REVISION B (16 JAN 2009)

DETAIL PLANNING APPLICATION

ARCHITECT	CHARLES KHOO RIBA - PROGETTI	DATE	06.05.2008
	109 CHETWYND ROAD LONDON NW5 1DA TEL:020 7482 5		
JOB TITLE	REAR EXTENSION TO 72 - 76 EVERSOLT STREET, LONDON NW1 1		
DRAWING TITLE	PROPOSED SECTION	DRAWN BY	CK
	PHASE 2	SCALE	1:100
		JOB NO	244
		DWG NO	P 6
		REV	B

SECTION B 1:100

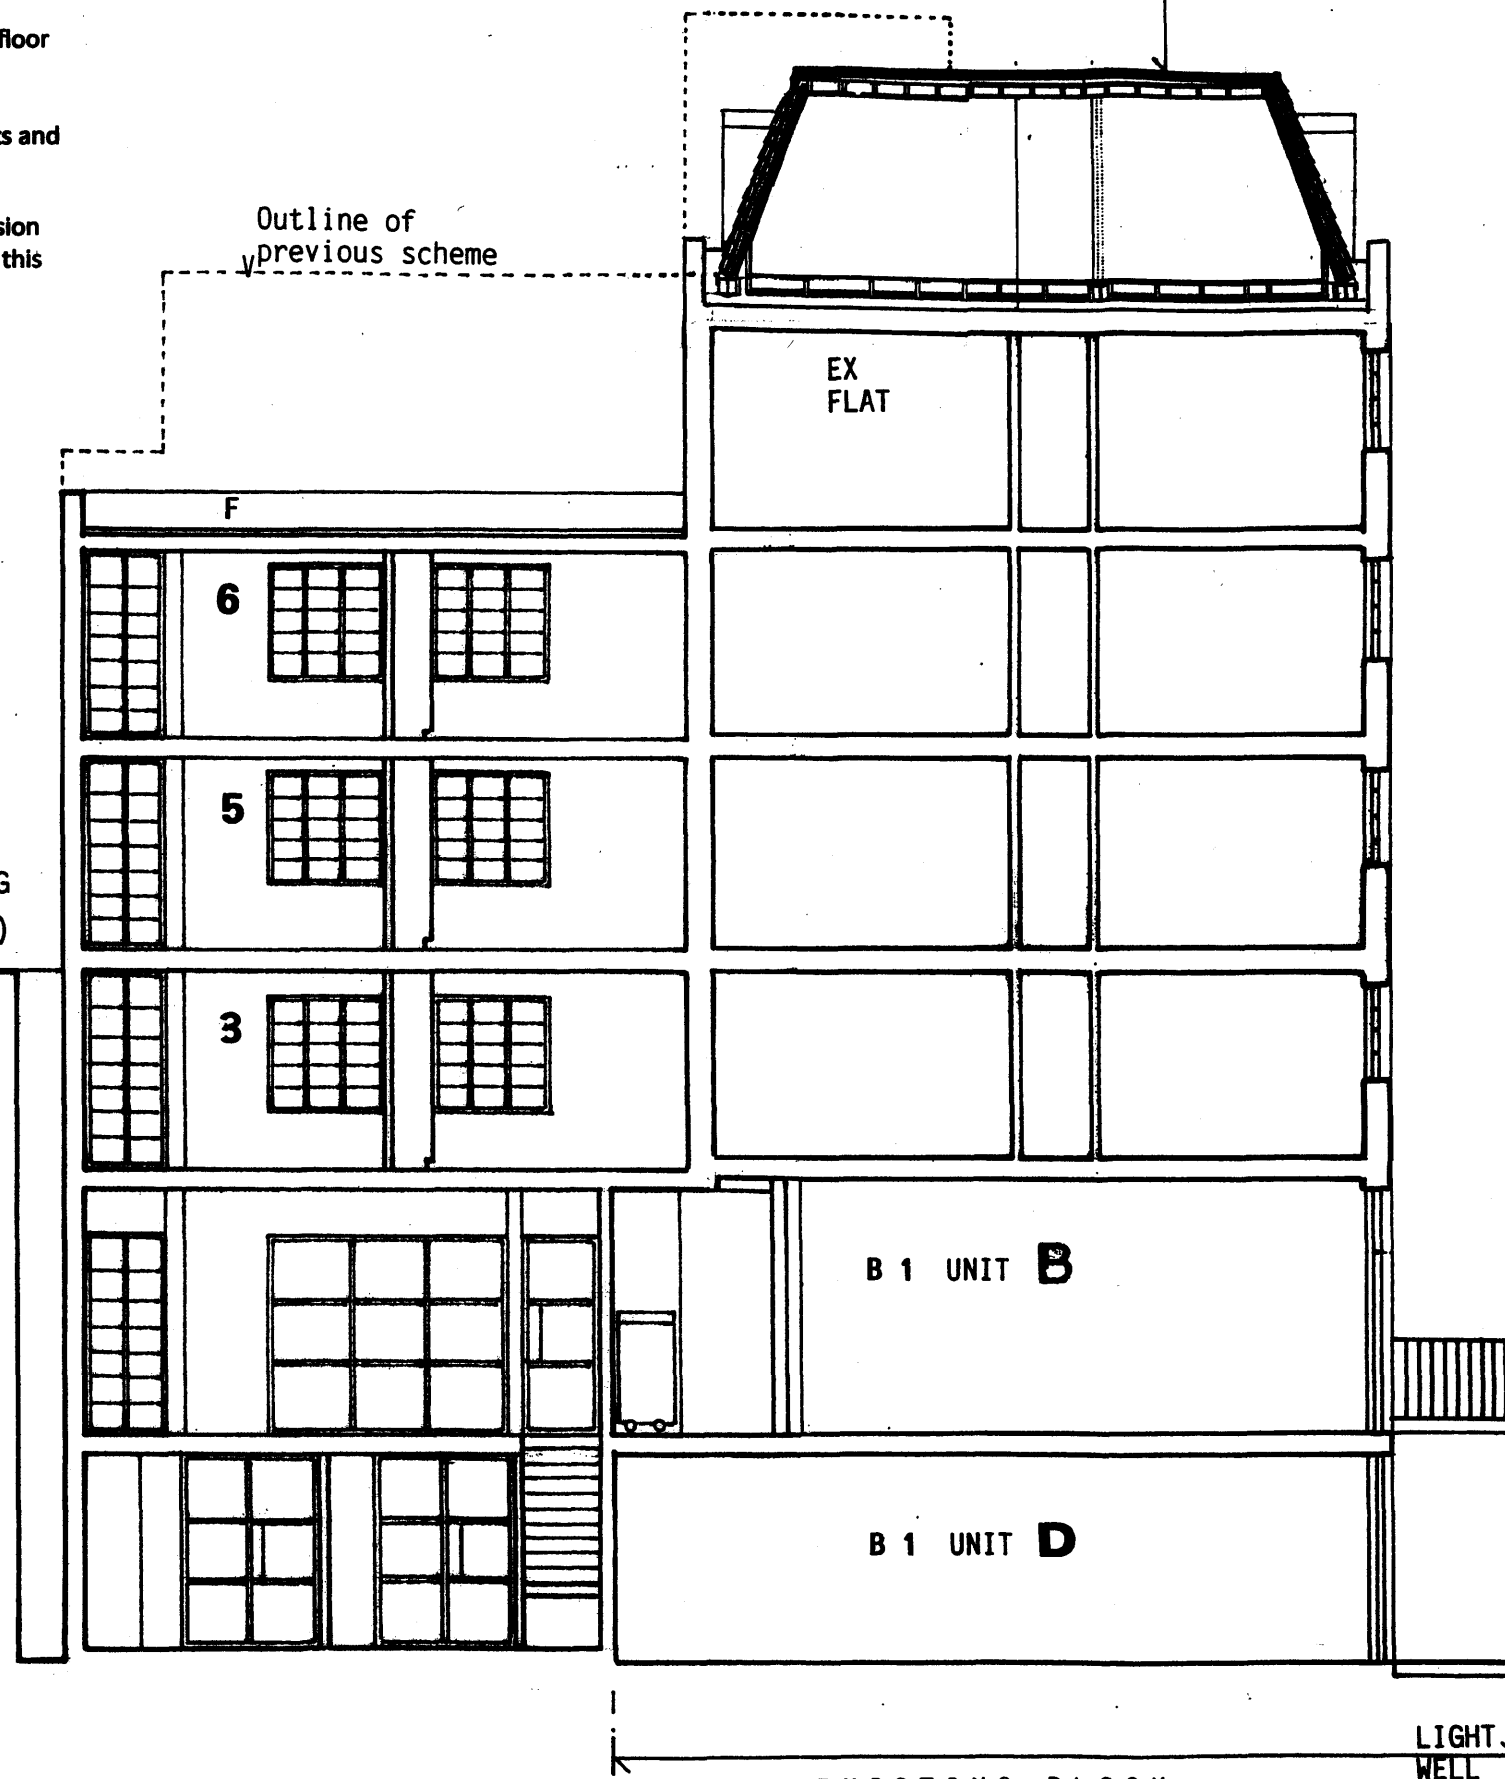
1. Previously approved (2006 / 05621) fifth floor extension revised to incorporate existing parapet with set backs and smaller dormers.
2. Mansard Roof extension for 2 flats included in this application.

1. Revised scheme for 6 Flats
2. Rear extension reduced in height by one storey and window details revised to match existing.
3. Omit Lift extension at roof level and previously approved Mansard Roof extension to continue around perimeter of existing block.

4. Ground floor commercial units A & B to remain as A2 units with level street access.
5. Disabled Wcs included to all commercial units A, B, C & D. Lift access included to Basement units.

6. Proposed Lift increased in size to 1100 wd x 1800 L (minimum dimensions)
7. Flat A can be adapted to wheelchair unit (optional)
8. Layouts to meet Lifetime homes standards:

- a. All entrance doors to have 900mm clear opening widths and 300mm to side of the leading edge of a all door entrances.
 - b. Wet floor gullies to be provided to concrete floor slab in bathroom.

- c. All window openings are to have glazing at minimum of 800mm above floor levels. Solid balcony upstands are to be no higher than 750mm with guarding edge designed so as not to obstruct viewing height of 800mm
